HALLS MILL SOUTH INDUSTRIAL PARK SUBDIVISION, RESUBDIVISION OF LOTS 3 & 4

Engineering Comments: FINAL PLAT COMMENTS (should be addressed prior to submitting the FINAL PLAT for acceptance and signature by the City Engineer):

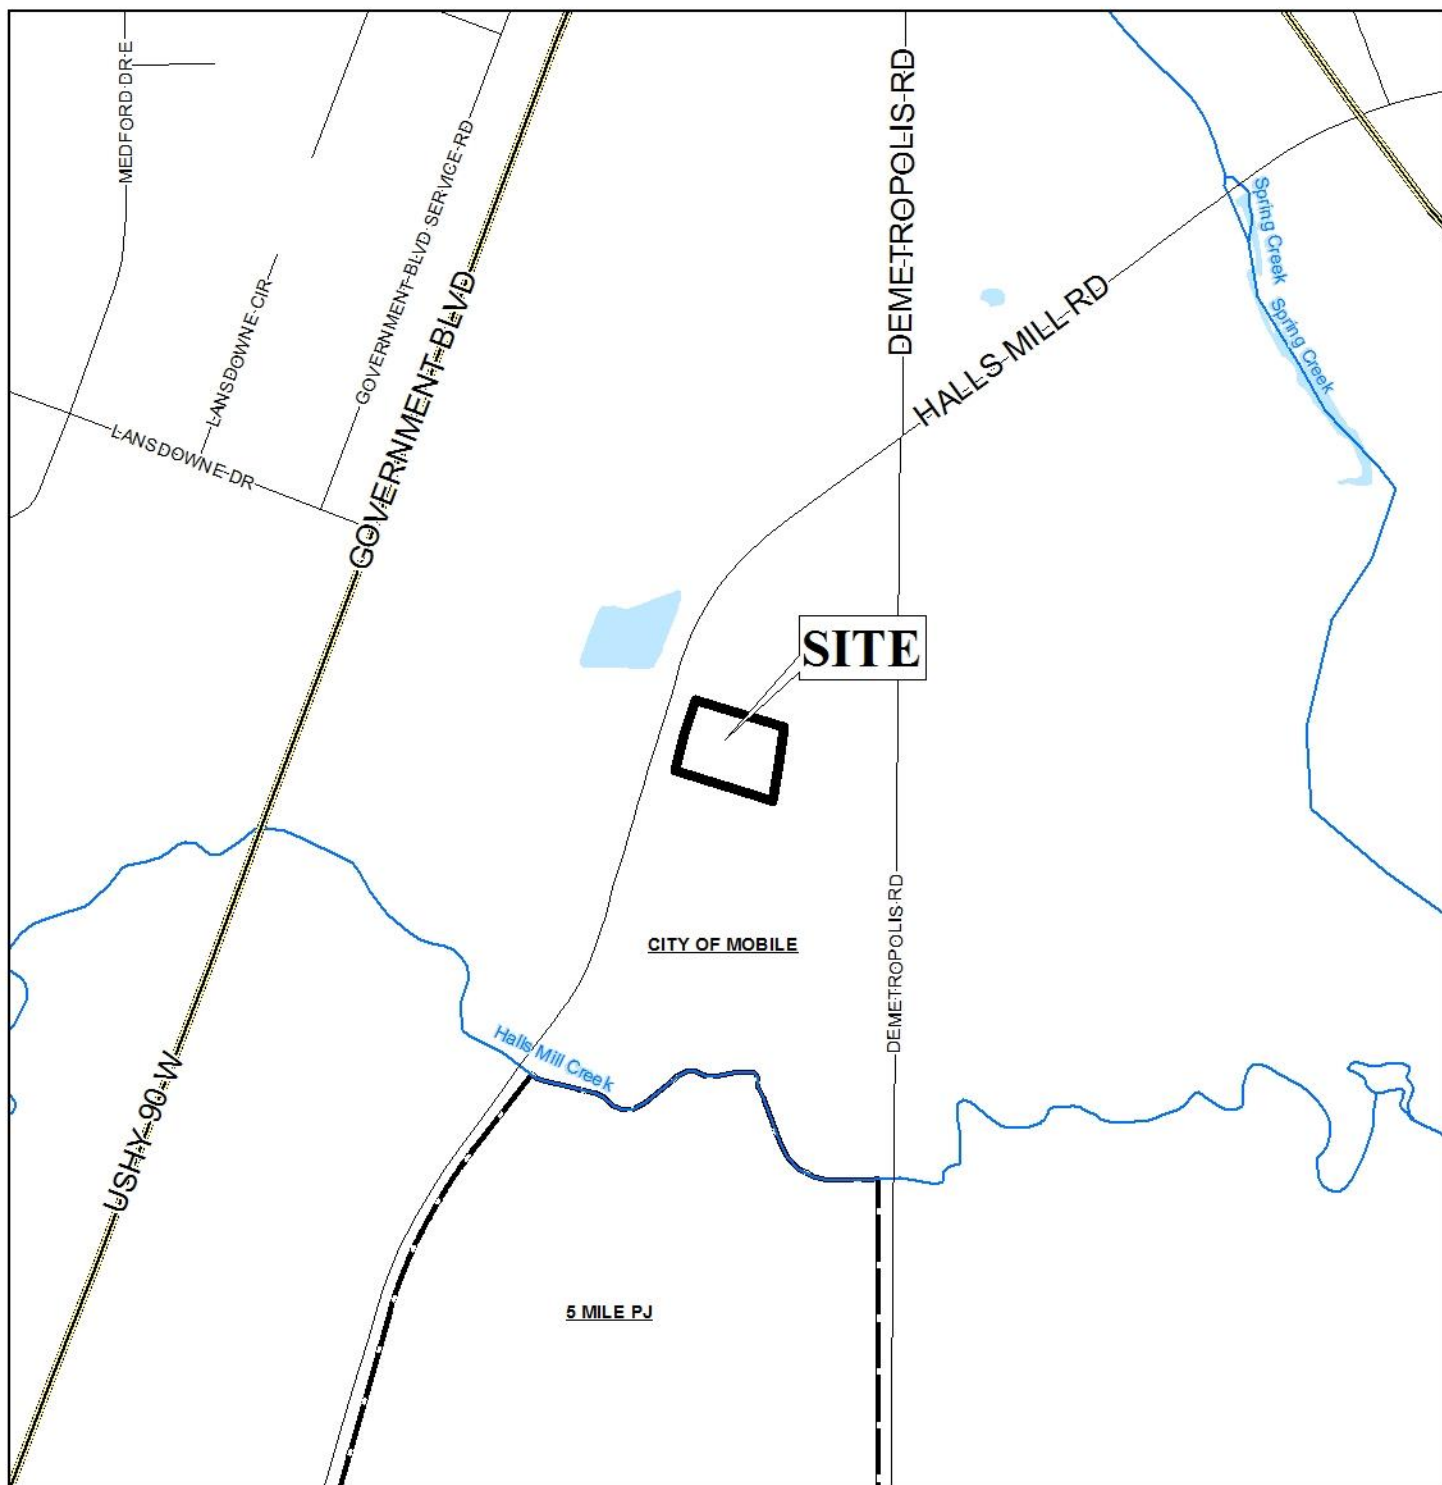
The proposed lot fronts Halls Mill Road, a collector street. As a collector street, Halls Mill Road requires a 70' right-of-way width. The right-of-way width, as indicated on the preliminary plat, reflects compliance with collector street standards and if approved, should be retained on the Final Plat.

A 25-foot minimum building setback line is depicted on the preliminary plat along Halls Mill Road and, if approved, should be retained on the Final Plat.

The proposed lot exceeds the 7,200 square foot minimum lot size requirements for lots served by public water and sanitary sewer systems. The preliminary plat provides the lot sizes in square feet and acres, and if approved, this information should be retained on the Final Plat as well.

As a means of access management, a note should be placed on the Final Plat, if approved, stating that the proposed lot is limited to its existing curb cut, with any changes in the size, design and location to be approved by Traffic Engineering and conform to AASHTO standards.

- 1) Retention of the 25' minimum building setback line along Halls Mill Road;
- 2) Retention of the lot size information on the Final Plat to be depicted in square feet and in acres;

- 3) Placement of a note on the Final Plat stating that the proposed lot is limited to its existing curb cut, with any changes in the size, design and location to be approved by Traffic Engineering and conform to AASHTO standards.
